Wisconsin Department of Transportation

Proposal #13: 2709-03-70, WISC 2018 239
Lovers Lane
CTH Q – CTH E
STH 164
Washington County

Letting of May 8, 2018

This is Addendum No. 01, which provides for the following:

PROJECT NO: 2709-03-70	HWY: STH 164	COUNTY: WASHINGTON	PAVING DETAILS - STH 164	SHEET 87	E

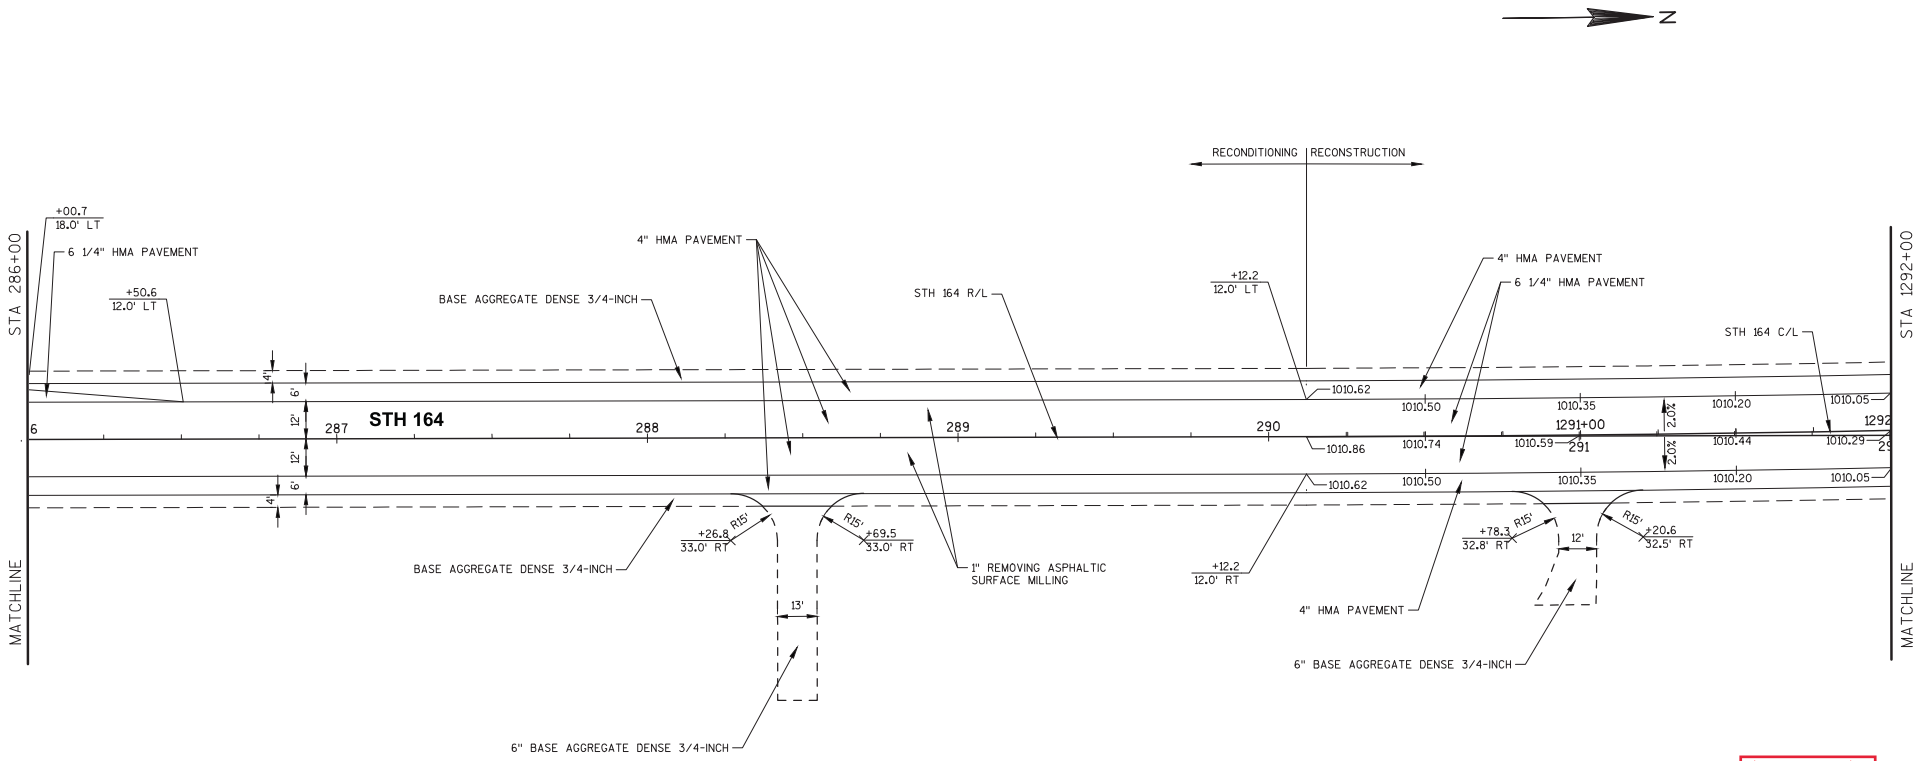
Revised Plan Sheets	
Plan Sheet	Plan Sheet Title (brief description of changes to sheet)
87 to 92	Paving Details – Revised Elevations
156	Storm Sewer – Revised Rim Elevation
159	Storm Sewer – Revised Pipe Class
169	Storm Sewer – Revised Pipe Class
171	Storm Sewer – Revised Pipe Class
172	Storm Sewer – Revised Pipe Class and Rim Elevations
176	Storm Sewer – Revised Rim Elevations
183	Storm Sewer – Revised Pipe Class and Rim Elevations
187	Storm Sewer – Revised Rim Elevations
189	Storm Sewer – Revised Rim Elevations, Removed H450 and P451
190	Storm Sewer – Revised Rim Elevations, Revised Pipe Class, Removed H450 and P451
275	Signing Removal Plan – Added note to 91R and 98R to move signs and poles to another location on project.
278	Signing Removal Plan – Revised note to move 134R instead of removing sign.
309	Permanent Signing Plan – Revised note for 178 to note moving sign instead of removing sign.
430	Alignment Plan – Revised Superelevation Table for STH 167 EB Curve 1

PROJECT NO: 2709-03-70	HWY: STH 164	COUNTY: WASHINGTON	CROSS SECTIONS: STH 164	SHEET 918A	E

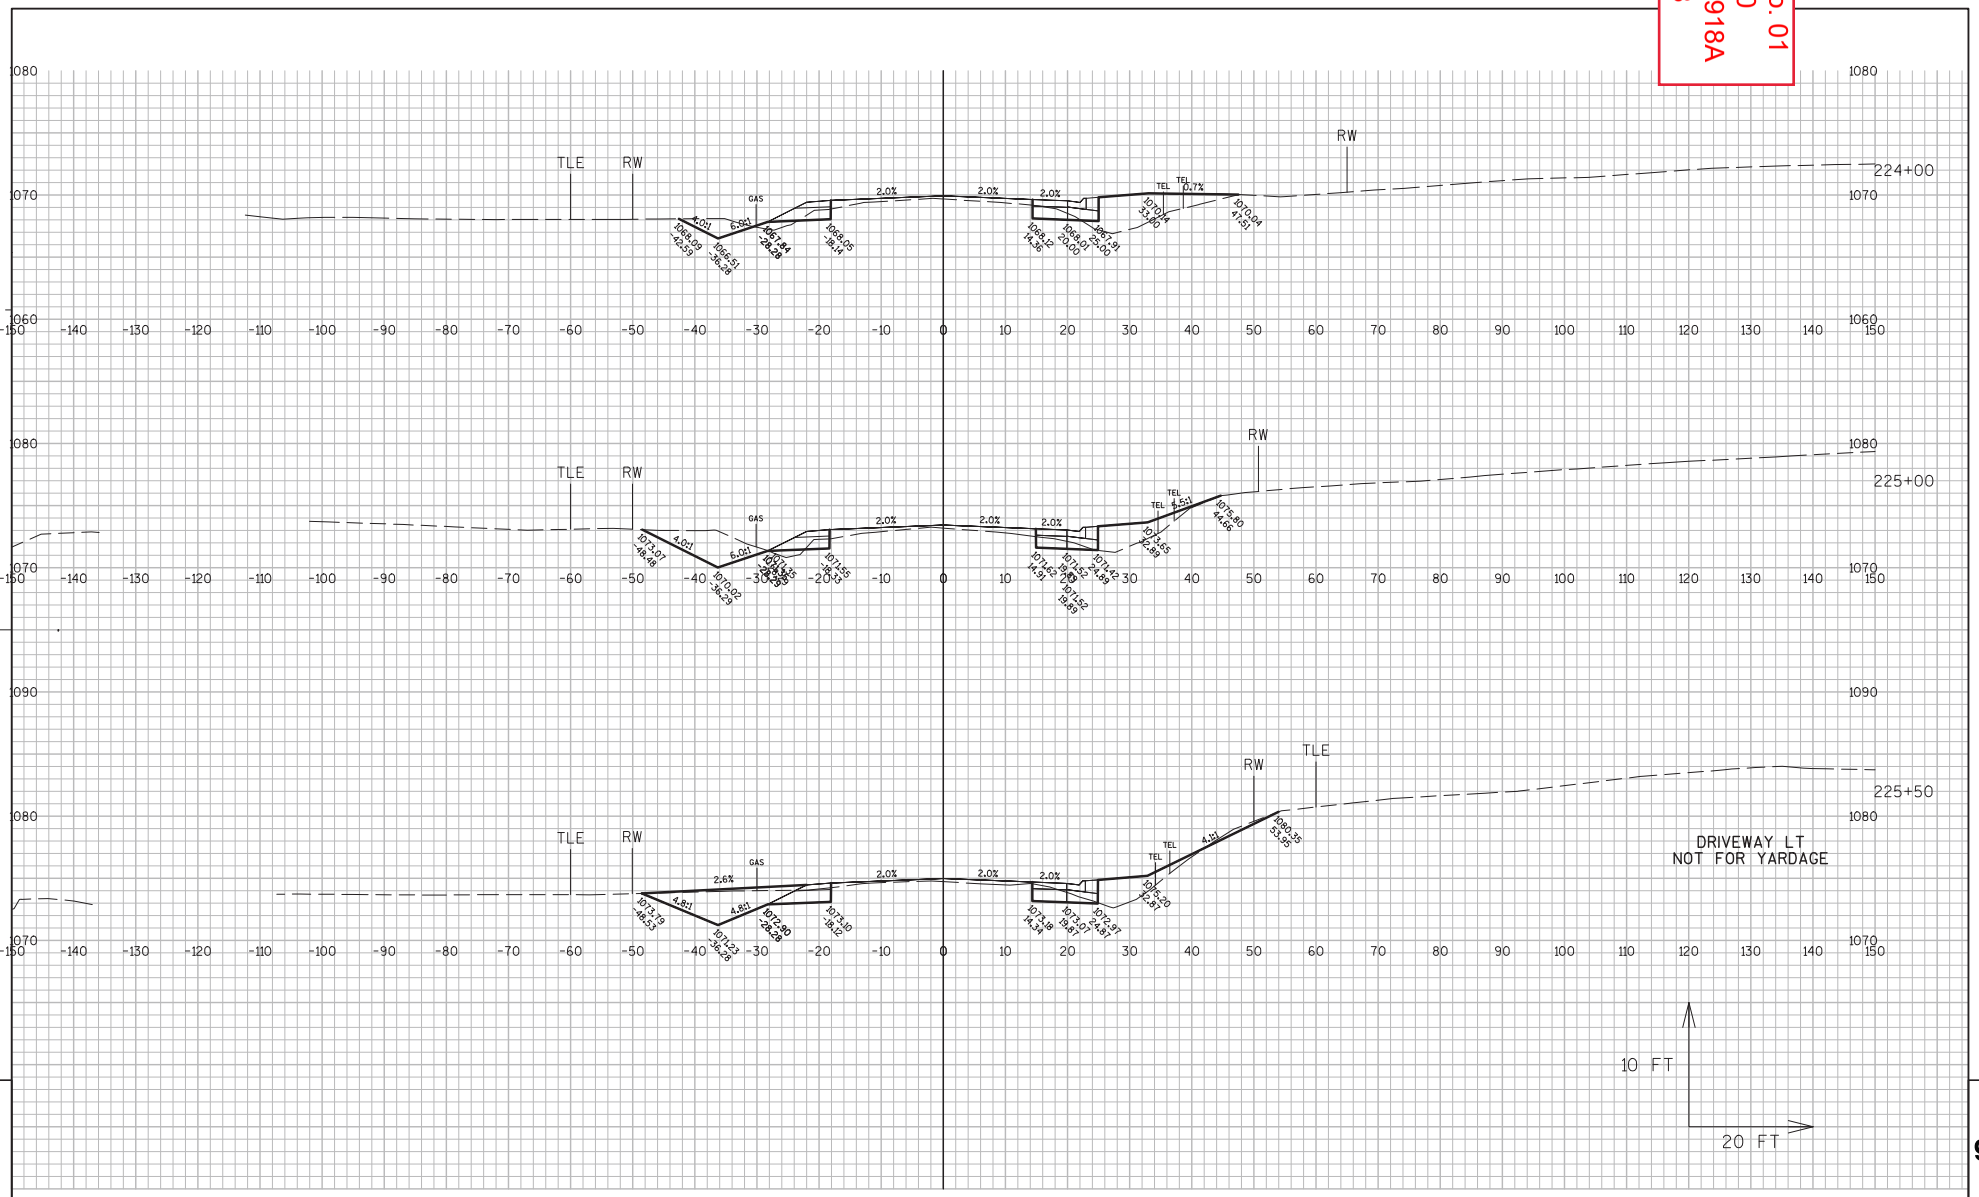
Added Plan Sheets	
Plan Sheet	Plan Sheet Title (brief description of why sheet was added)
918A	Cross Sections (Sheet was missing from plan set)
